SUBJECT: PRELIMINARY SITE PLAN REVIEW (SP JPLN2022-0021) - Proposed Forum Flats 200-unit residential development, South side of Kirts, West of Livernois (295 Kirts; PIN 88-20-28-252-016), Section 28, Currently Zoned BB (Big Beaver) District

Preliminary Site Plan Review For City of Troy, Michigan

Applicant: Cypress Partners
Project Name: Forum Flats
Location: 295 Kirts Boulevard
Zoning: BB, Big Beaver
Action Requested: Preliminary Site Plan

C-3.0

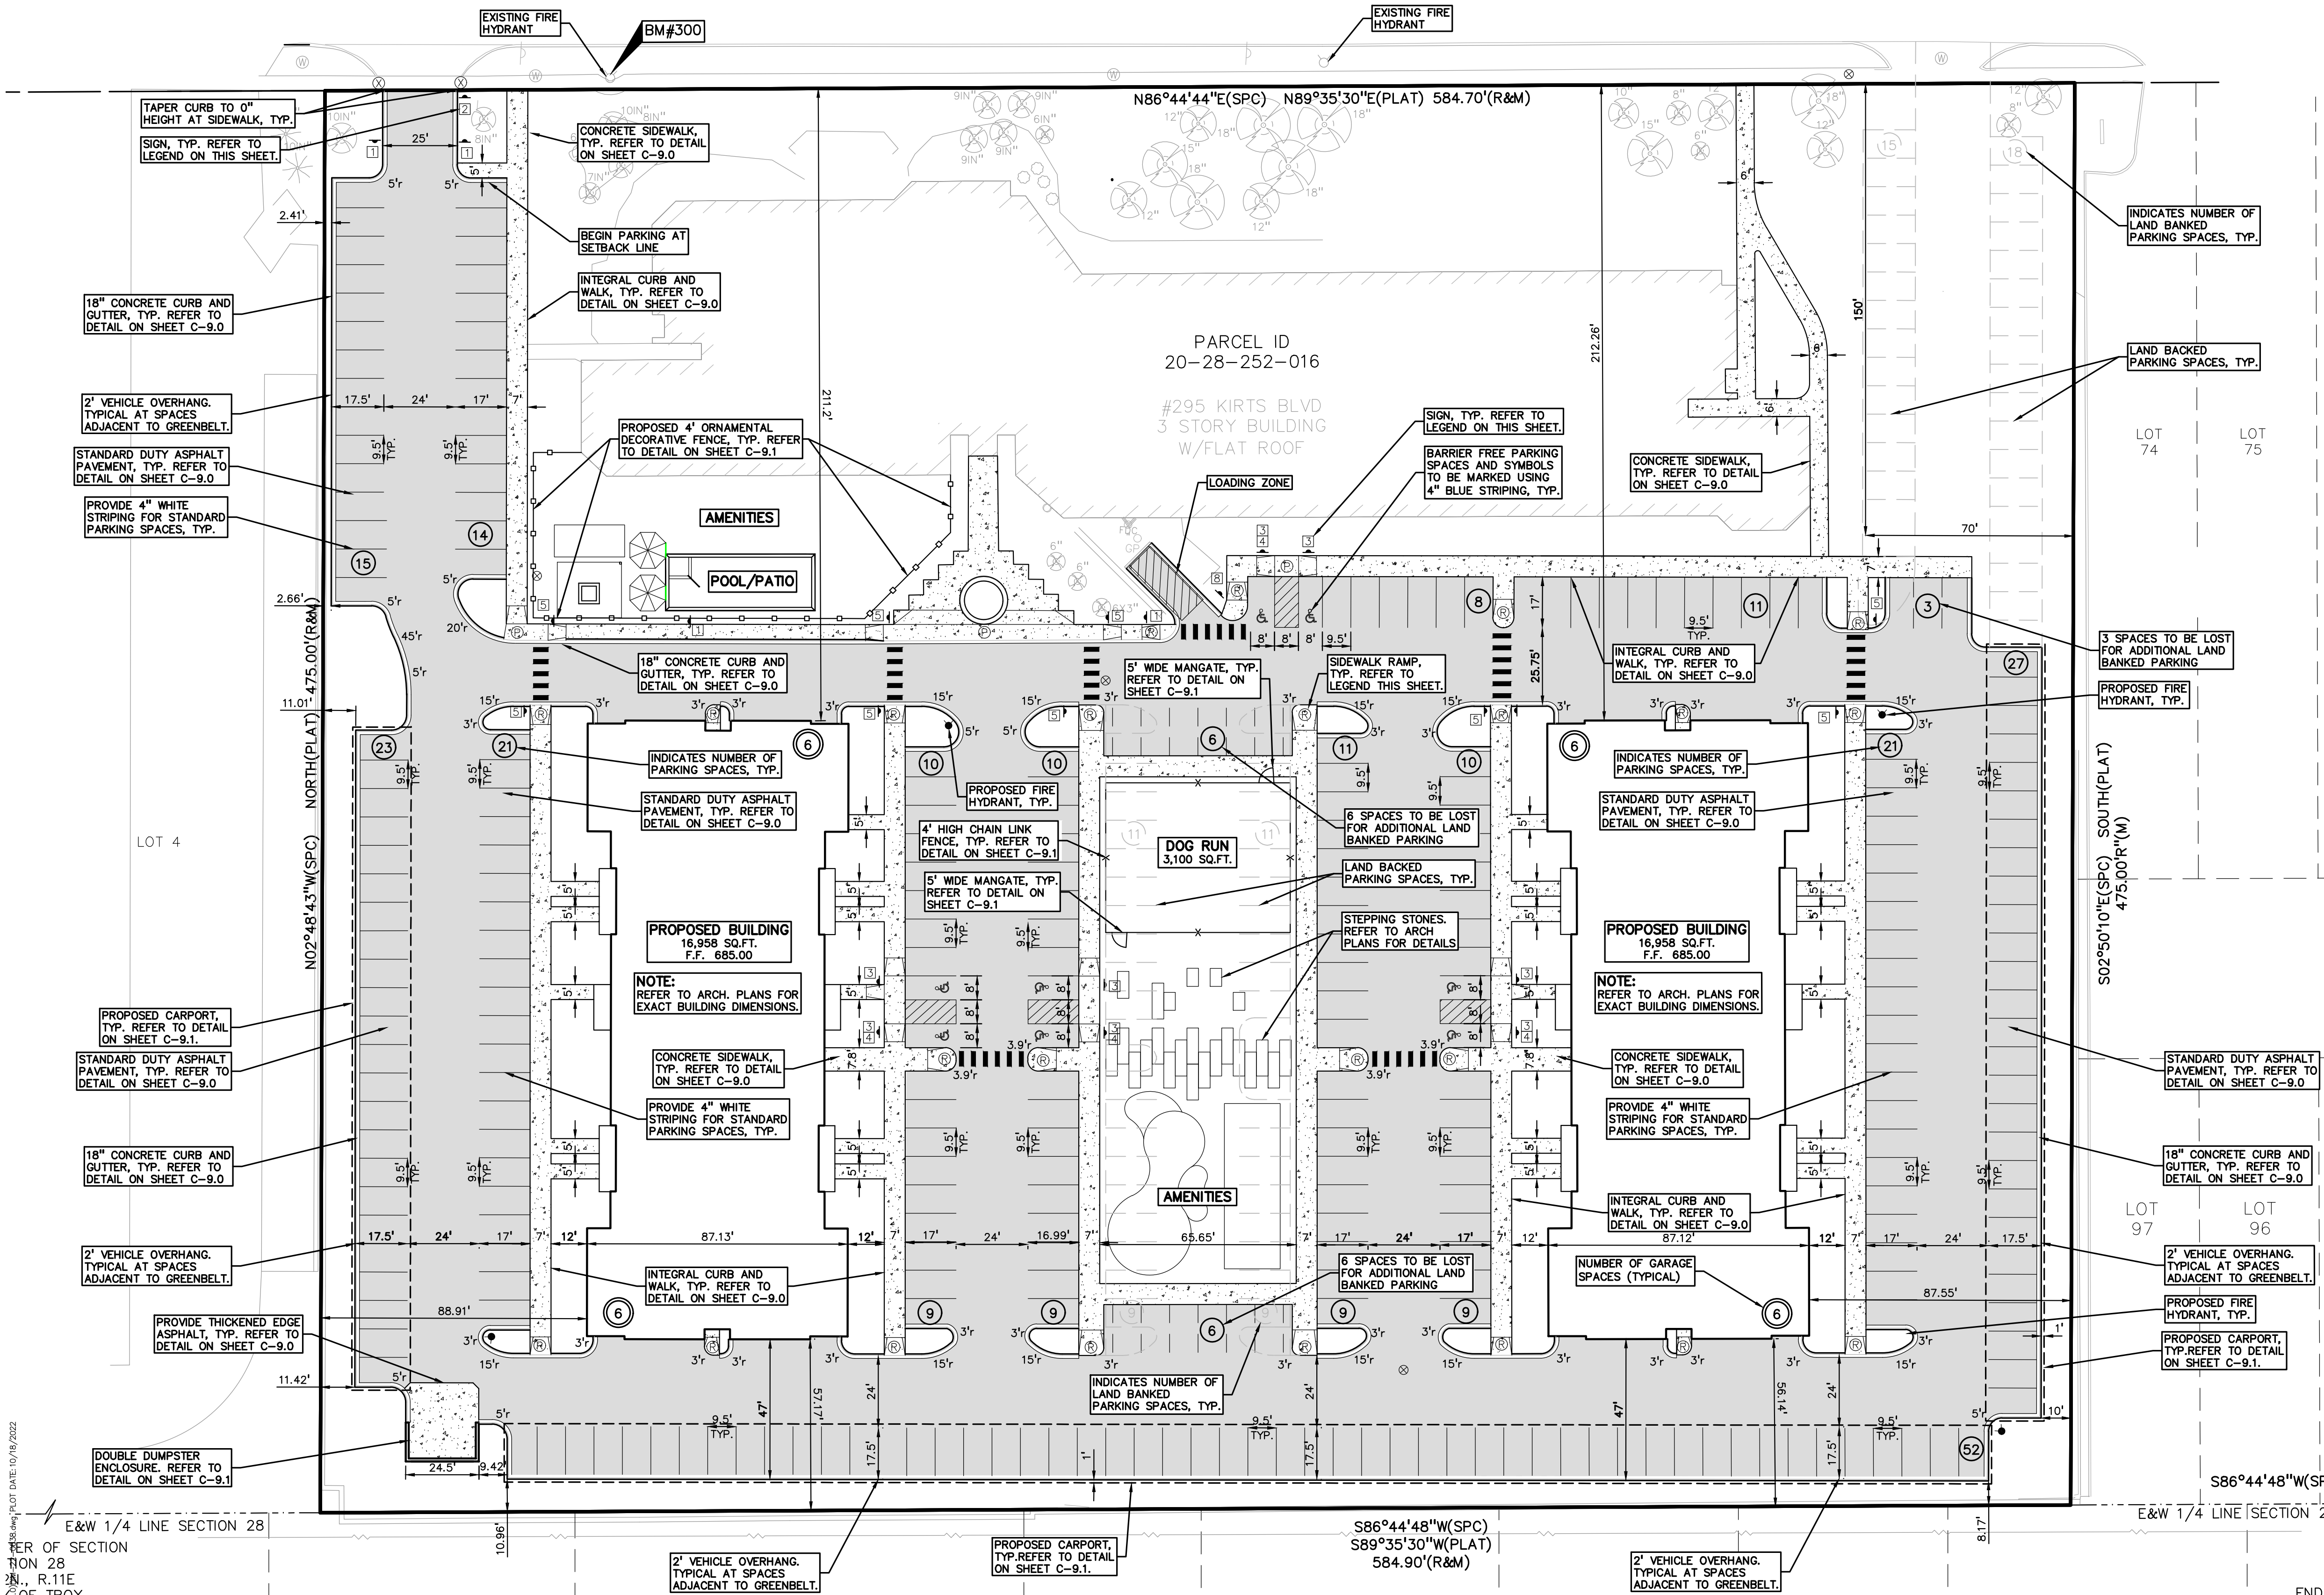
By ordinance the applicant is required to provide 366 spaces. They are providing 308 built spaces plus a proposed 58 landbanked spaces. Landbank parking allows for designating a portion of the site that would be required for parking to be held and preserved as open space, rather than constructed as parking. The proposed landbanked parking is located to the east of the existing building, above the underground detention, and in the central amenity area. Please note that if all site parking were needed, the central amenity area would be converted to parking.

The applicant is providing a parking ratio of 1.54 spaces per unit. OHM has reviewed the parking and has provided a memo for the Planning Commission review.

Planning Commission may grant parking reduction if they support the justification for the reduction. Planning Commission may want to consider conditioning landbank approval on the use of grasscrete parking areas to replace turf grass.

Items to be Addressed: Planning Commission to consider the use of landbanked parking, and the potential loss of the central site amenity if landbanked parking is constructed.

1. Update landscape plan to show landscaping in landbanked parking area above underground stormwater detention prior to Final Site Plan Approval.
2. Provide grasscrete parking areas to replace turf grass in landbanked areas.
3. Provide cut sheet of the proposed lighting fixtures prior to Final Site Plan Approval.

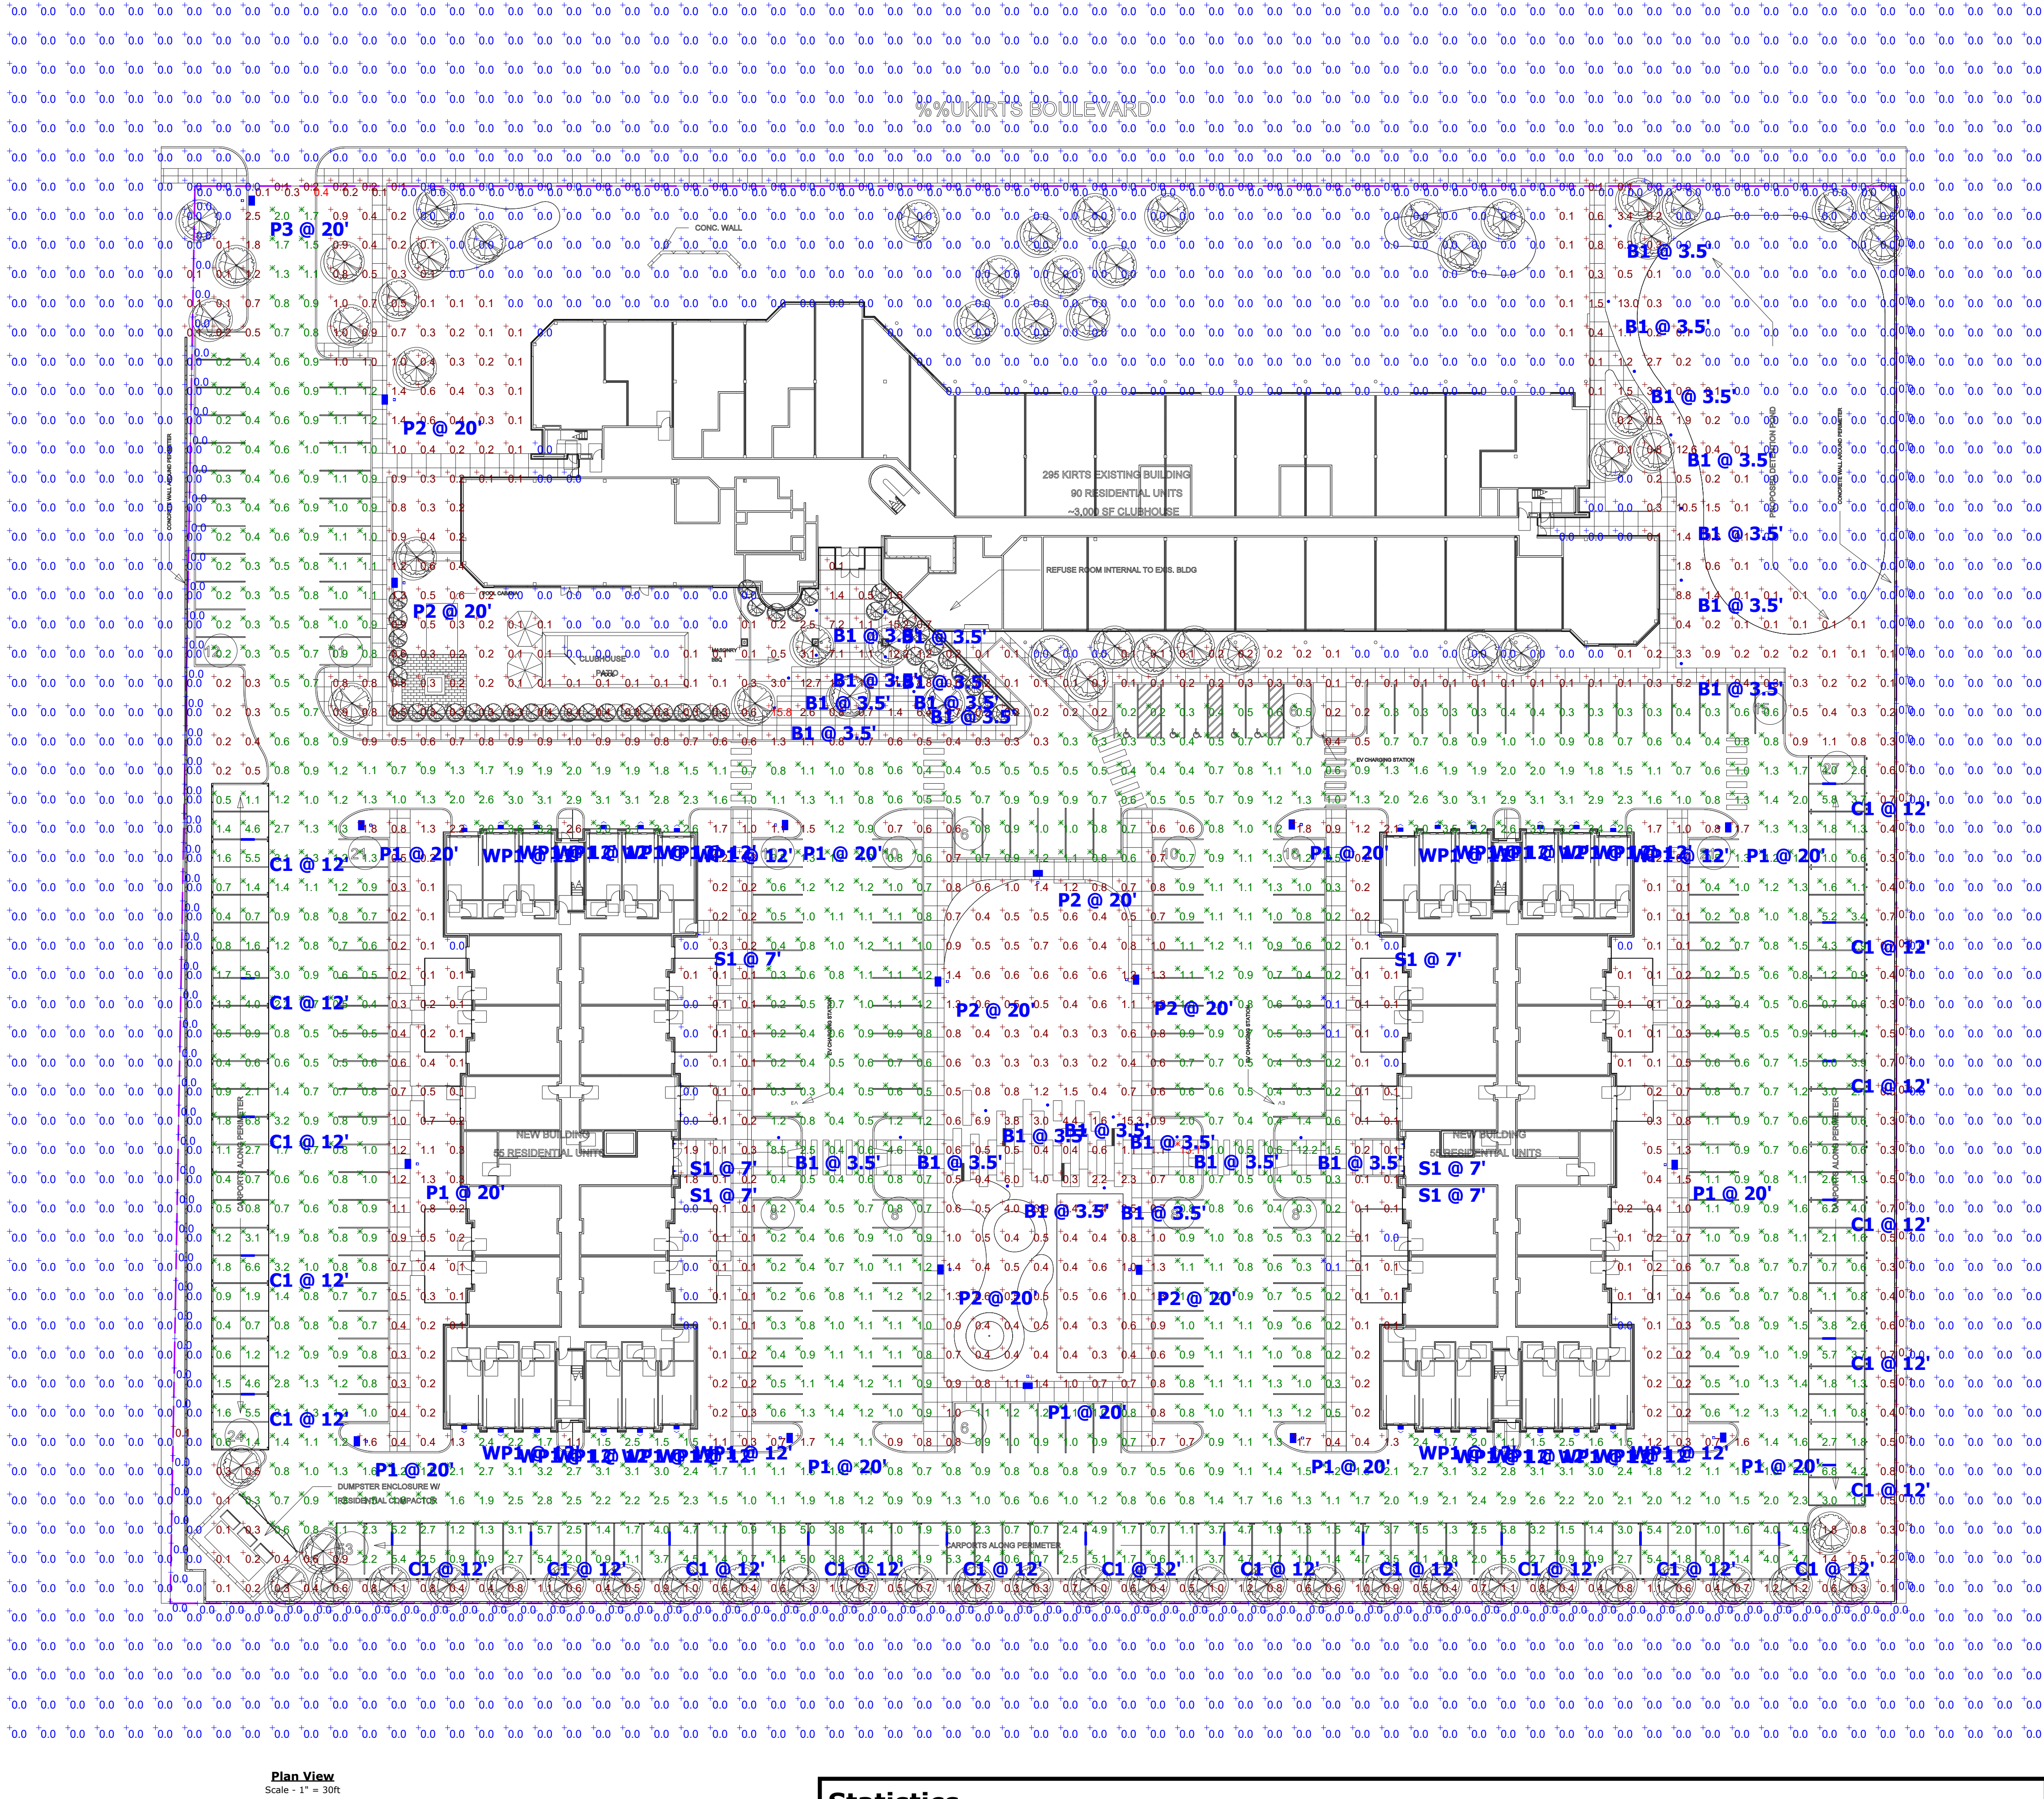
The applicant has provided a photometric plan. The applicant is proposing 19 pole lights, 22 under car port lights, 24 bollard lights, and 30 buildings lights. Photometrics need ordinance requirements but the applicant did not provide cut sheet of the proposed fixtures.

Items to be Addressed: Provide cut sheet of the proposed fixtures.
